**CERTIFICATE OF APPROPRIATENESS**

**Property:** 2015 W. Gray Street, Suite J, Tract 11, 12 and 13A, ABST 696 O Smith Subdivision. The property includes a combination of one and two-story, stucco and ceramic tile clad commercial buildings.

**Proposal:** Alteration – Alter four facades on a non-original commercial structure. The alterations include the following: Remove existing stucco and reface building with new stucco.

**HAHC Action:** Approved

**WEST ELEVATION – FRONT**

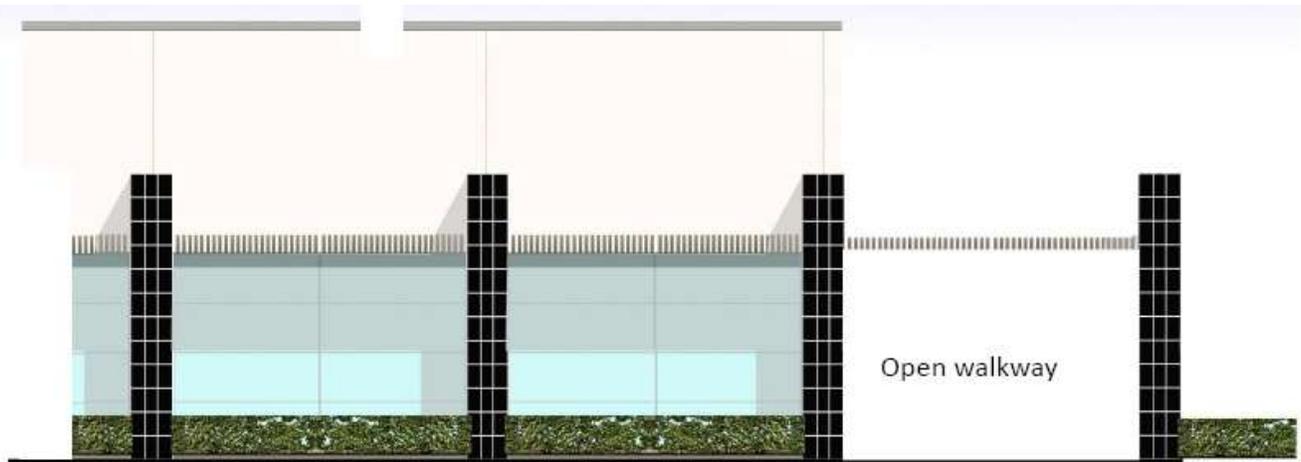
**Front Elevation:** The building features five single lite windows and four columns clad with brick ceramic tiles. The  
**(West)** buildings feature a canvas awning. The five windows will be replaced with five divided lite windows, the black ceramic tiles will be replaced with new black ceramic tiles, and the existing awning will be replaced with a wood trellis.

**EAST (REAR) ELEVATION**

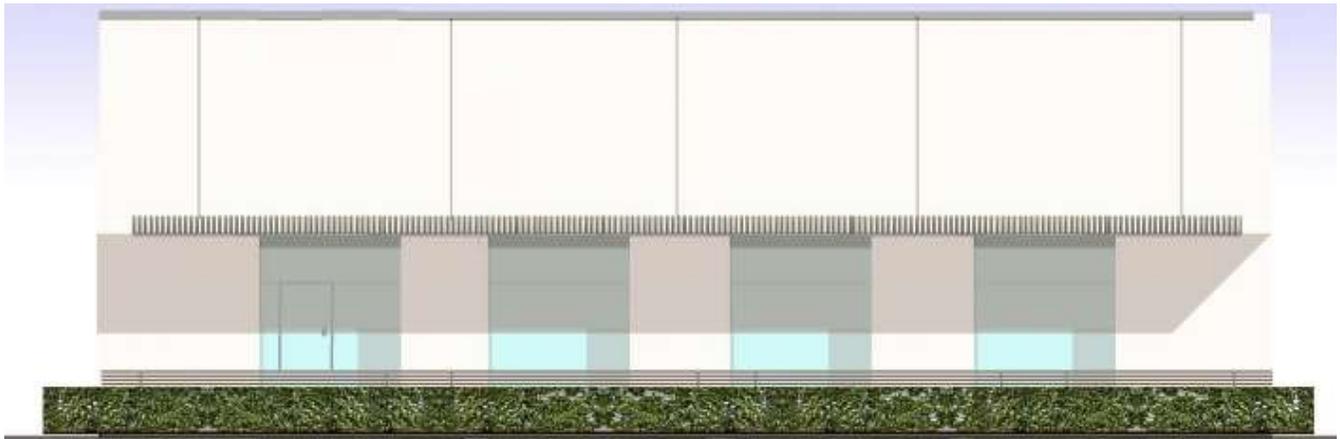
**Rear Elevation:** The building features five single lite windows, a single lite entry door and a canvas awning. The  
**(East)** windows will be replaced with four divided lite windows and the single lite entry door will be replaced with a new single lite entry door. The existing awning will be replaced with a wood trellis.
